**CITY OF TEMPE  
DEVELOPMENT REVIEW COMMISSION**

**Meeting Date: 12/10/2019  
Agenda Item: 3**

**ACTION:** Request a Development Plan Review for a new 3-story multi-family development consisting of eleven (11) dwelling units for GEM APARTMENTS, located at 2063 East Lemon Street. The applicant is Moderna Architects.

**ARCHITECTURAL SITE PLAN**

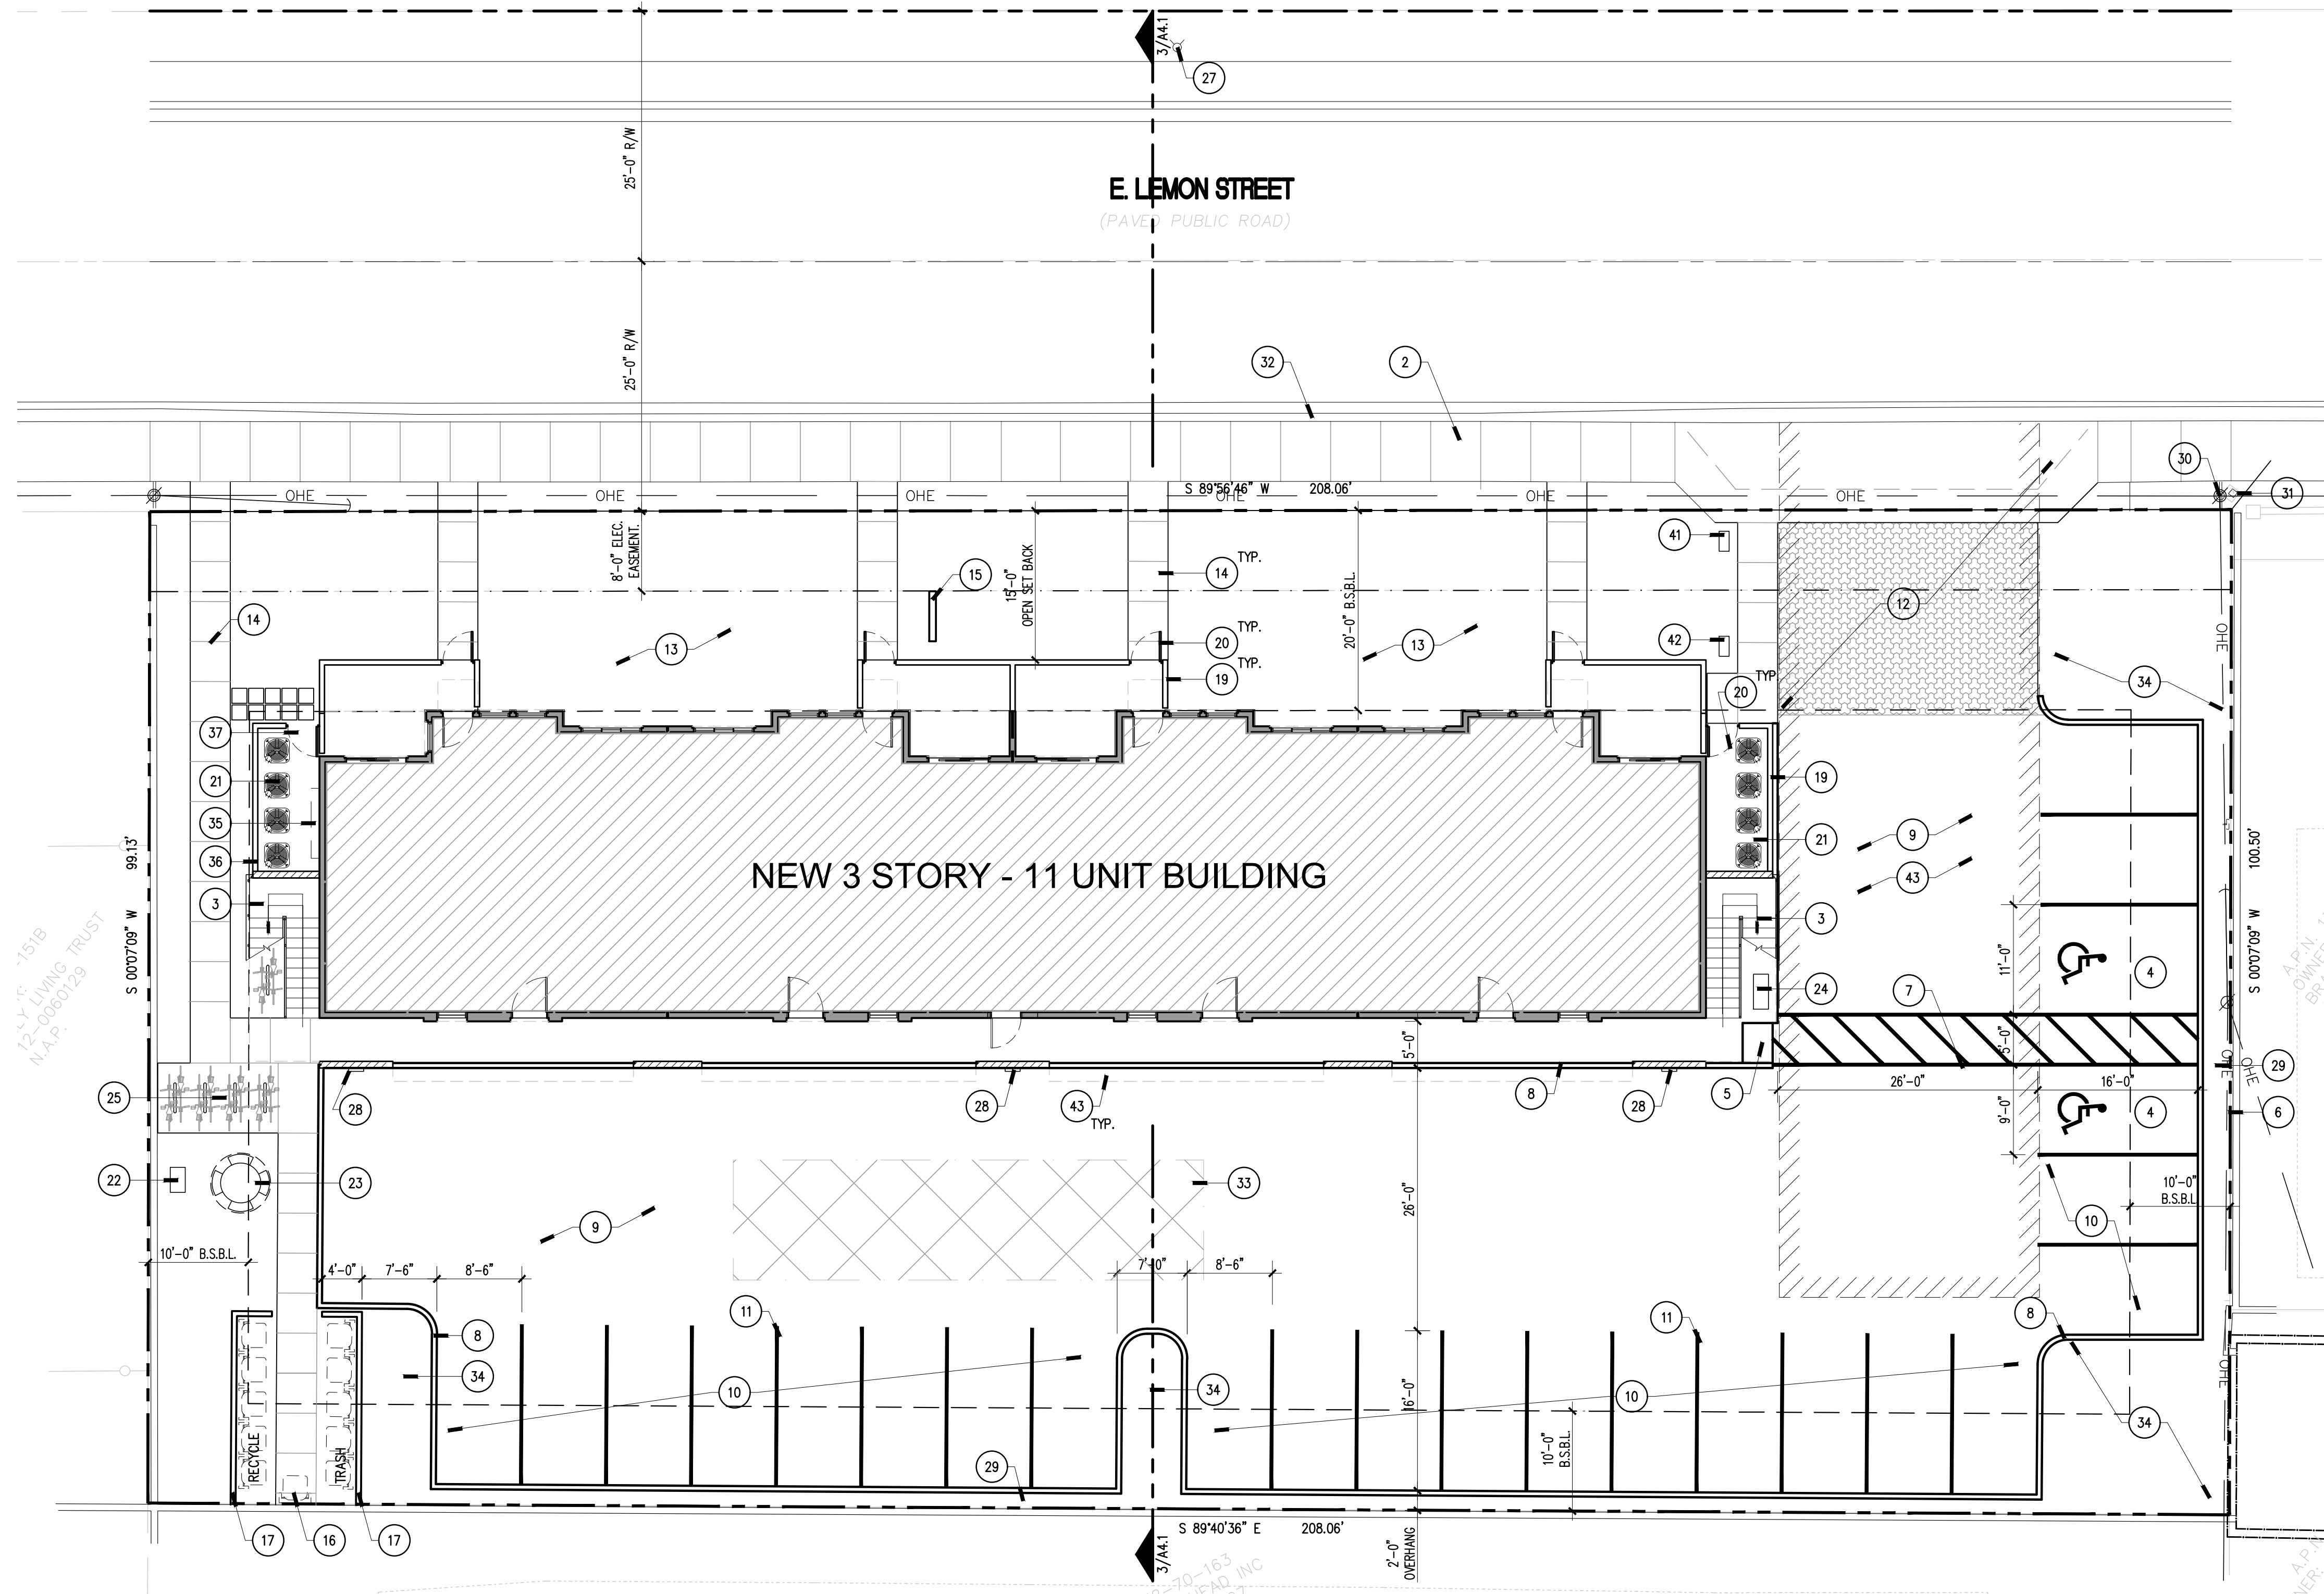
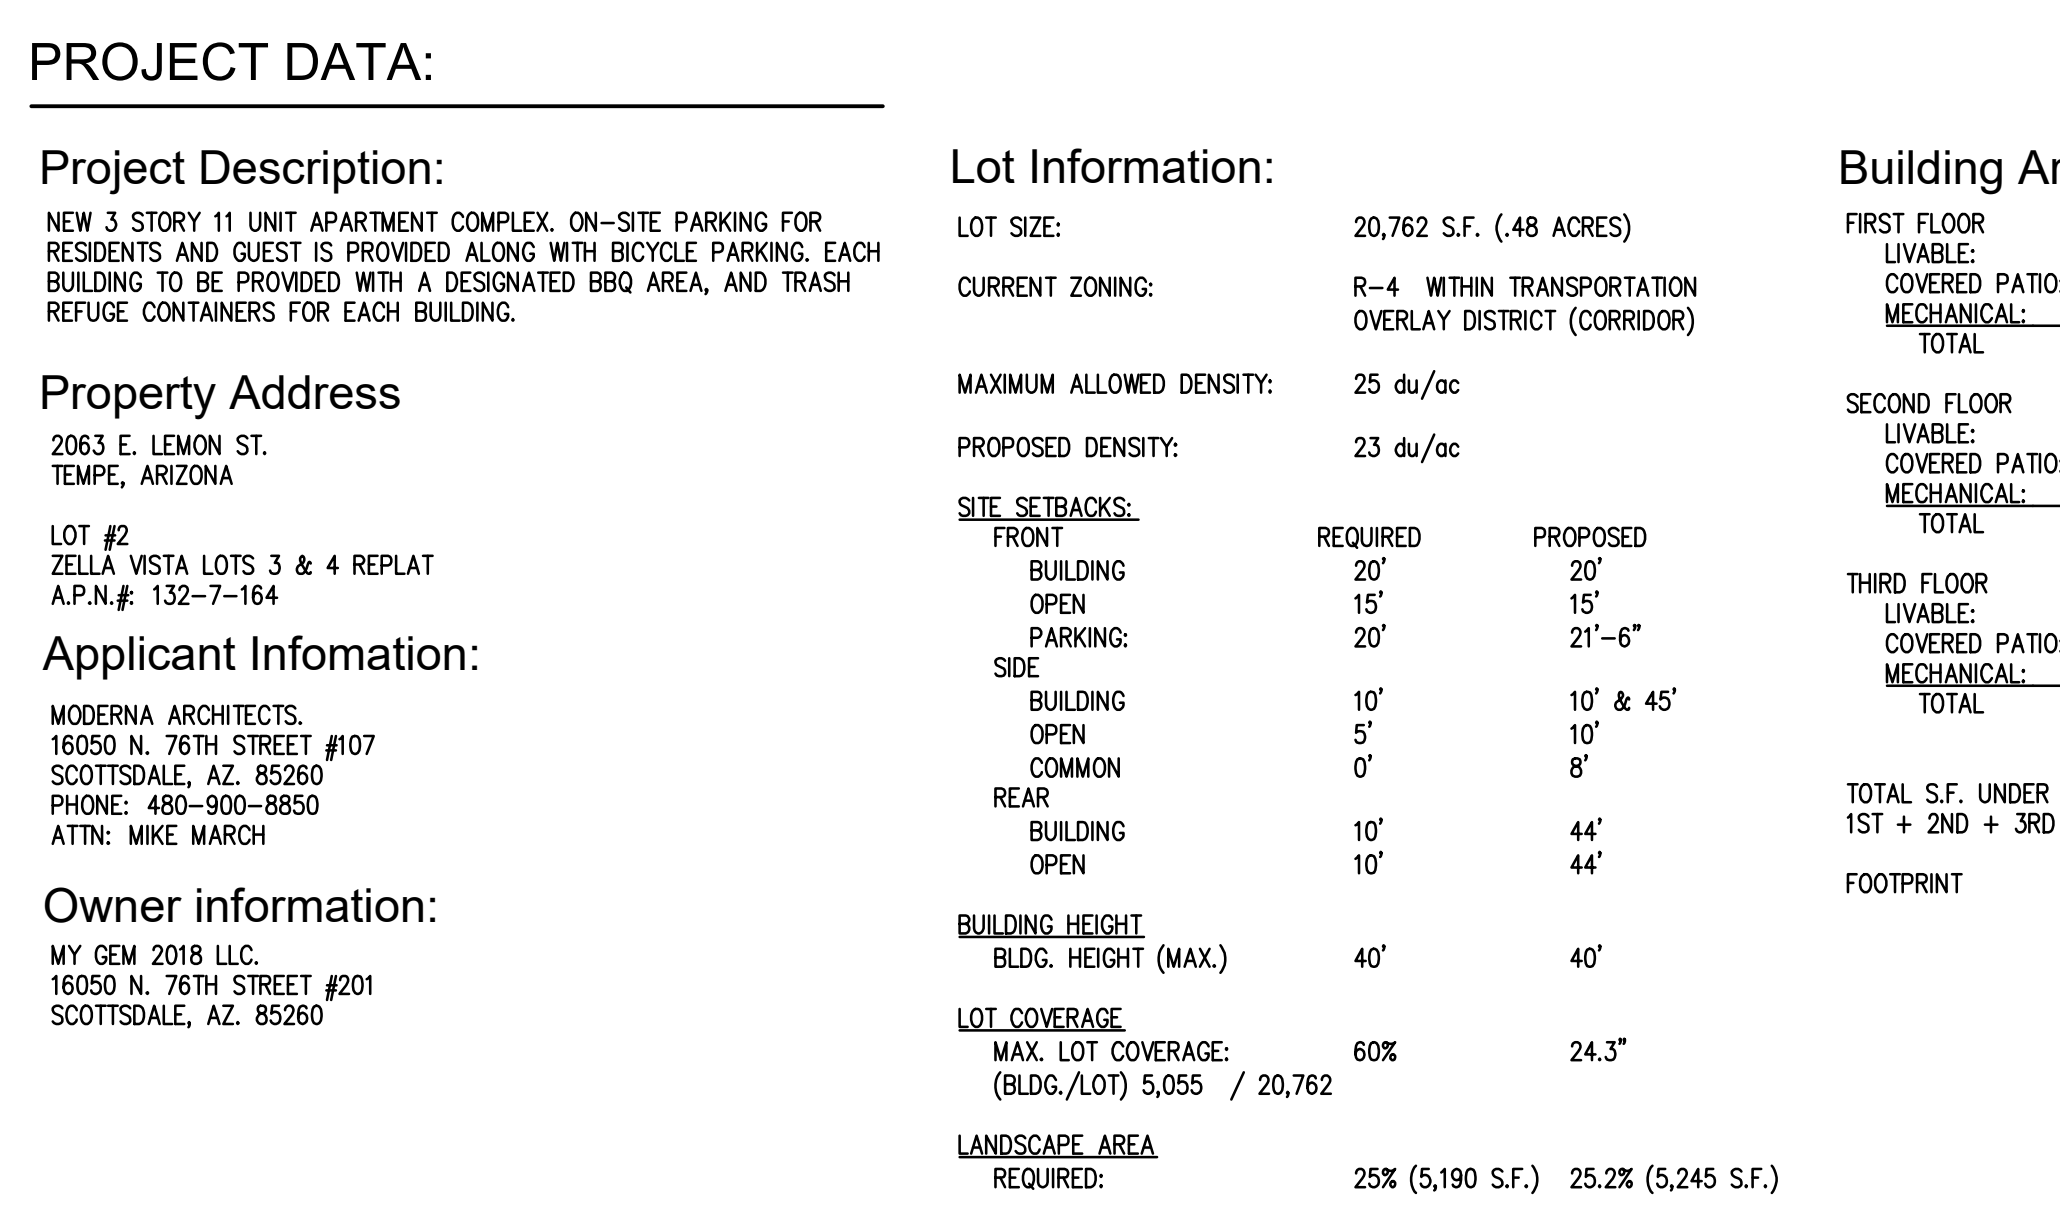
4. Provide service yard and mechanical (cooling tower/generator) yard walls that are at least 8'-0" tall as measured from adjacent grade or are at least the height of the equipment being enclosed, whichever is greater. Verify height of equipment and mounting base to ensure that wall height is adequate to fully screen the equipment.

5. Provide gates of steel vertical picket, steel mesh, steel panel or similar construction. Where a gate has a screen function and is completely opaque, provide vision portals for visual surveillance. Provide gates of height that match that of the adjacent enclosure walls. Review gate hardware with Building Safety and Fire staff and design gate to resolve lock and emergency ingress/egress features that may be required.

6. Provide upgraded paving at driveway consisting of integral colored unit paving. Extend this paving in the driveway from the right-of-way line to 20'-0" on site and from curb to curb at the drive edges. From sidewalk to right-of-way line, extend concrete paving to match sidewalk.

PRELIMINARY  
LANDSCAPE  
PLAN

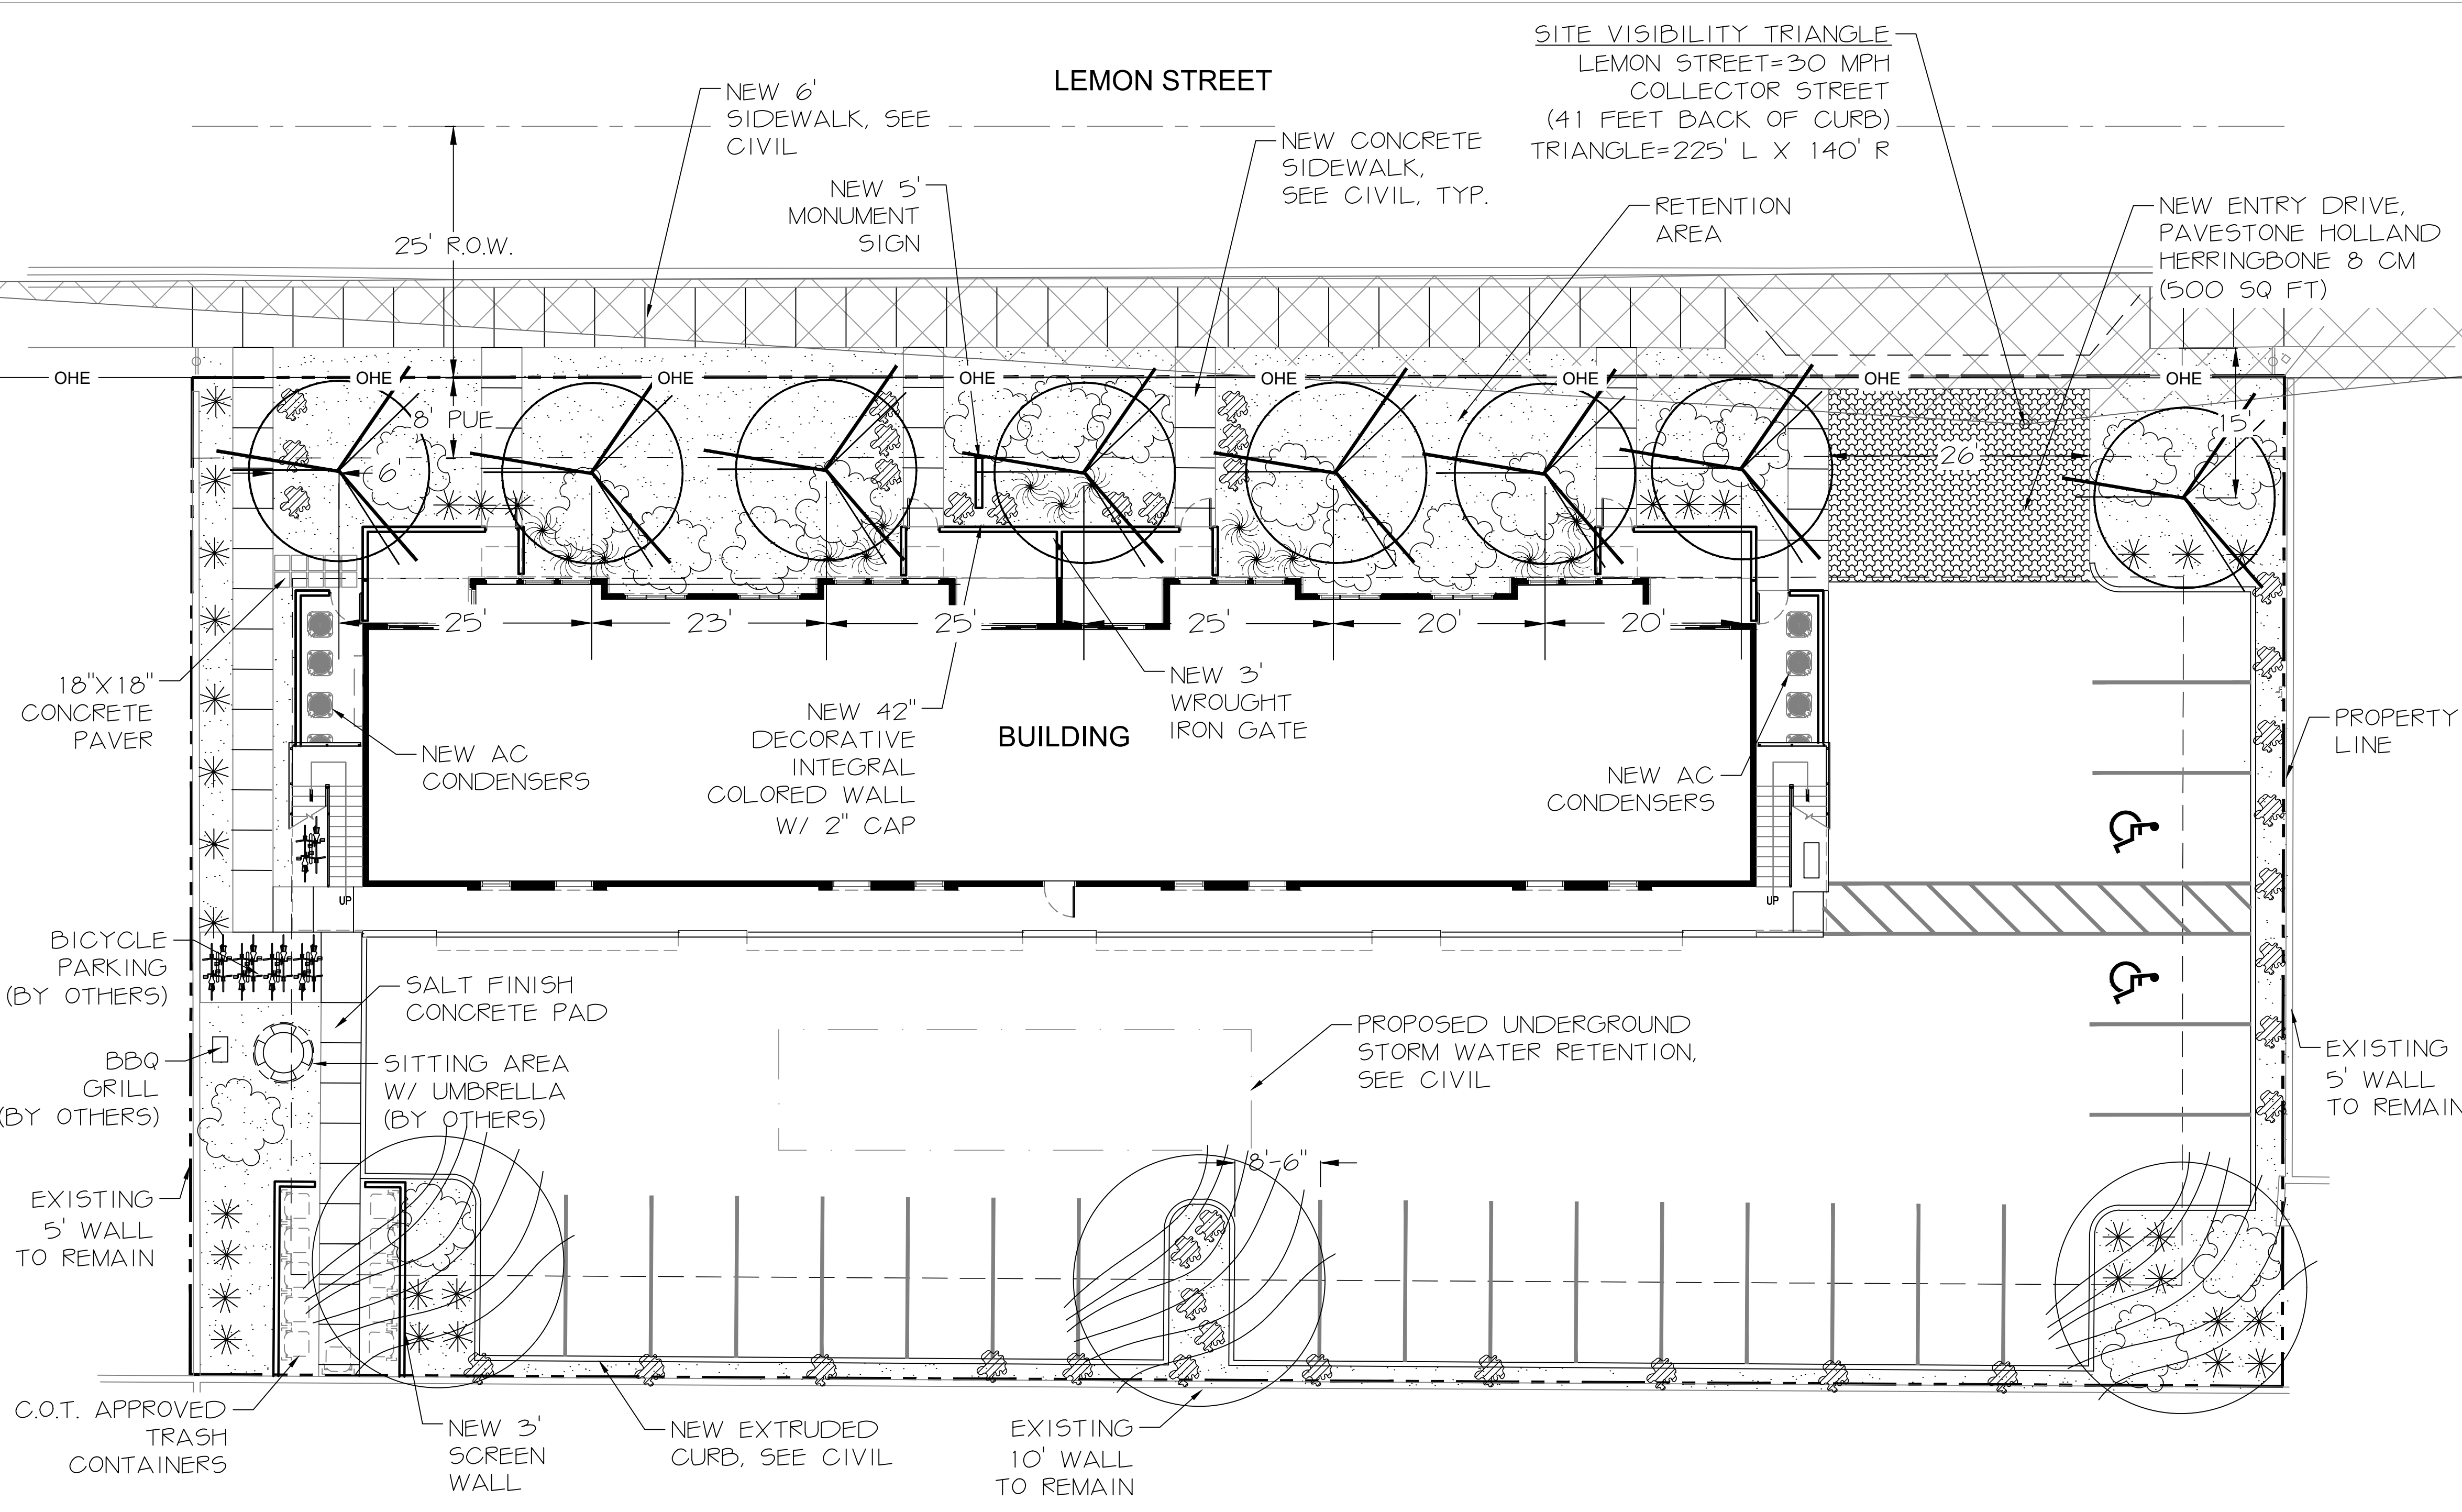
16. **Proposed street trees shall be replaced with Chinese Elm, Arizona Ash or other fast-growing tree with a large canopy at maturity.**
17. **Developer shall incorporate trees and understory plants identified in historic plant palette for the Apache Character Area plan. The Community Development Department must approve specimens selected prior to issuance of building permits, a separate minor development plan review for landscape may be required.**

18. **Provide a minimum of 60% vegetative ground cover along the street frontage and 50% in all other landscape areas. These percentage should not include tree canopies.**
